Ground floor - current proposed changes continued

3.5 Building D plans

3.6 Roof Plan

Building C - ground floor plan - current proposals

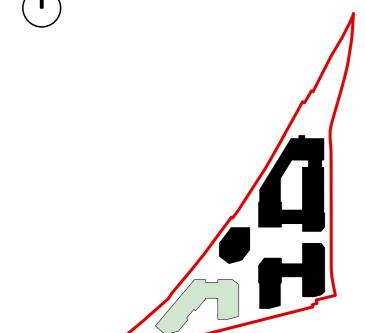
$\overbrace{\mbox{10}\mbox{}}$ Middle stair core has direct escape door to outside via new corridor

1 bedroom apartment and 2 bedroom apartment have swapped positions to allow for the new corridor between stair cores (no. 2)

(12) External access into courtyard removed

(13) New corridor to outside for external access to bin and bike stores

All bike stores and bin stores now accessed externally, and bin stores include two sizes of bins - 1100 litre and 240 litre bins

Building C - seventh floor plan - current proposal

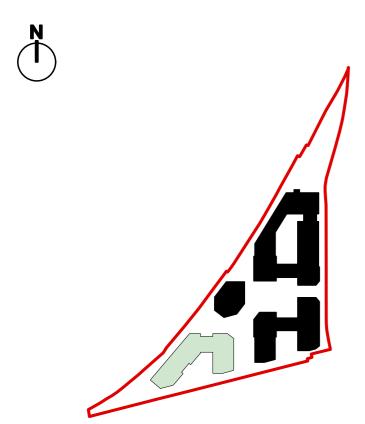
- 1 Introduction of second staircase
- (2) Updated riser layouts within residential cores
- Adjustments have been made to internal layouts including party walls, the arrangement of flats and apartment layouts in order to maintain unit mix and NIA
- A projectng balcony has been introduced to the east facade of block CB in place of the inset balcony previously shown
- 5 Doors to residential terrace added on seventh floor of block C

Building D - ground floor plan - November 2021 proposal

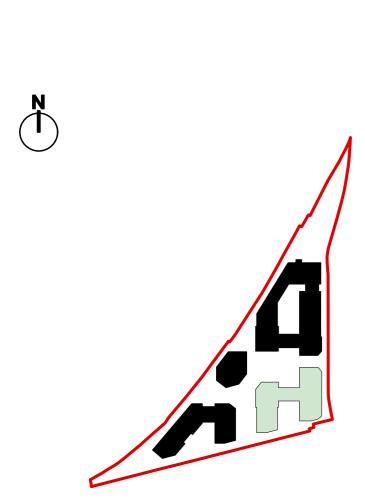
A change to the application boundary was made in an addendum document in 2021 that pulled the boundary away from the network rail fence line following a review of the title plan

2 Internal residential lobby amended to become external under-croft

Building D - ground floor plan - current proposal

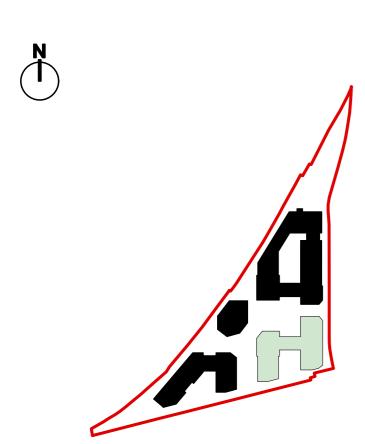
The following changes refer to Block DA (eastern building) only.

- 1 New lobbied corridor and escape door to the south
- 2 Substation and switchrooms have been rearranged due to new corridor and escape door, with the commercial GIA remaining unchanged. Plant rooms now accessed externally
- 3 New external doors to access Life Safety Switchroom
- 4 Bin stores include two sizes of bins 1100 litre and 240 litre bins

Building D - ground floor plan - current proposal

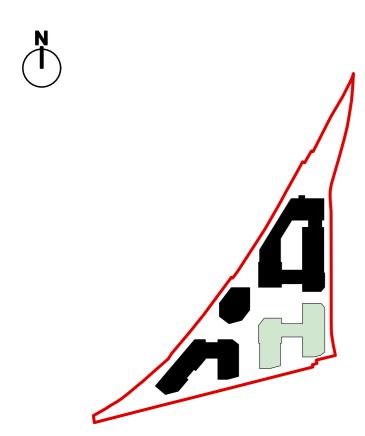
The following changes refer to Block DB (western building) only.

- 1 a 225mm (or 22.5cm) extension to the north and north-west.
- 2 Introduction of second staircase
- Adjustments made to the configuration of spaces at ground floor to accommodate a direct escape for the second stair, comply with fire regulations, and maintain unit mix
- 4 Updated riser layouts within residential cores
- Internal access to bin and bike stores from residential corridors removed for fire safety purposes
- (6) Western stair cores have direct escape door to outside
- (7) Bin stores include two sizes of bins 1100 litre and 240 litre bins

Building D - fourth floor plan - current proposal

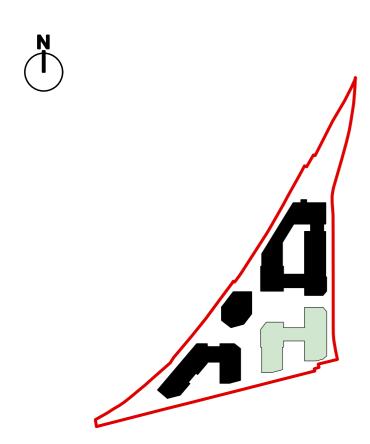
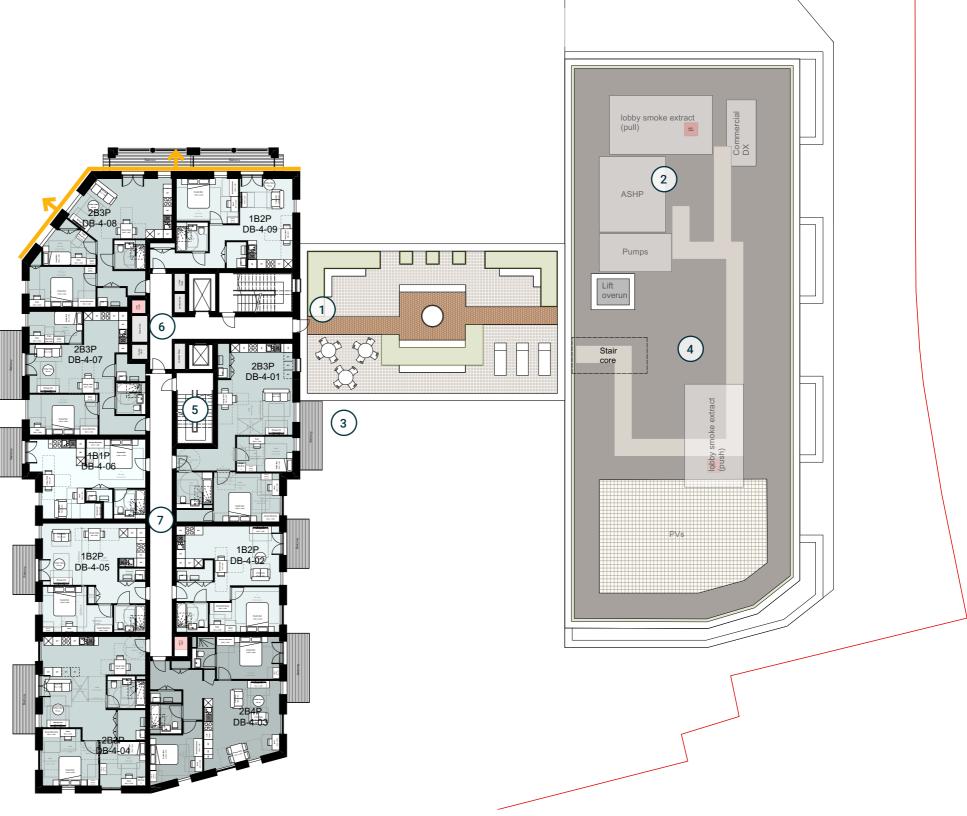
Doors to residential terrace added on fourth floor of western block D (Core DB)

2 Roof plant arrangement amended to reflect current MEP advice.

3 Balcony extended

Revised green roof layout to reflect adjustments to size and locations of plant space and lift cores

The following changes refer to Block DB (western building) only.

5 Introduction of second staircase

6 Updated riser layout within residential core

Adjustments made to internal layout to maintain unit mix

Roof Plan

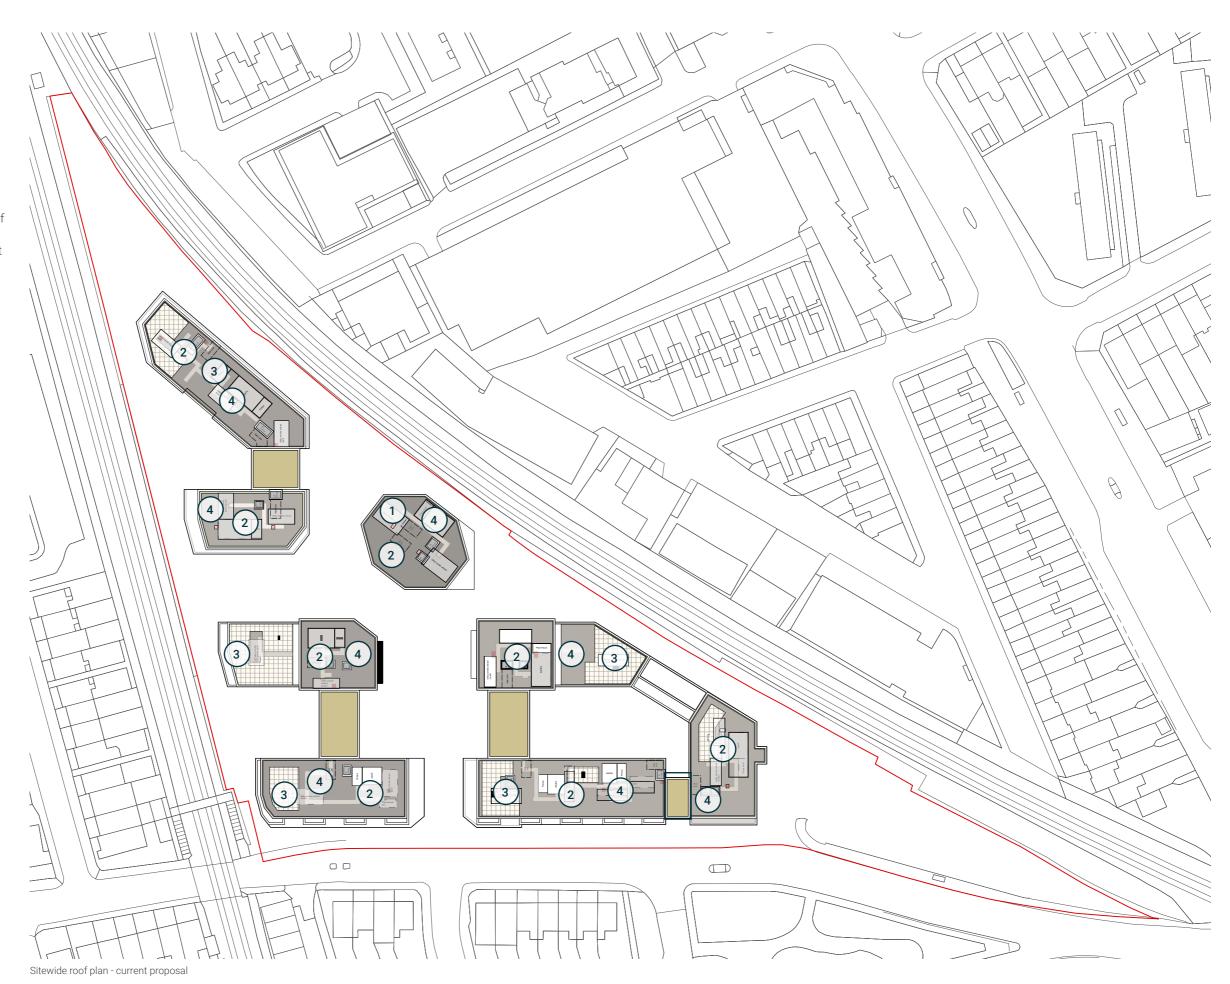
1 Loss of resident-accessible roof terrace

2 Consolidation of roof plant

3 Updated PV and AOV locations

Additional green roof coverage. Green roof layout has been revised to reflect adjustments to size and locations of plant space and lift cores
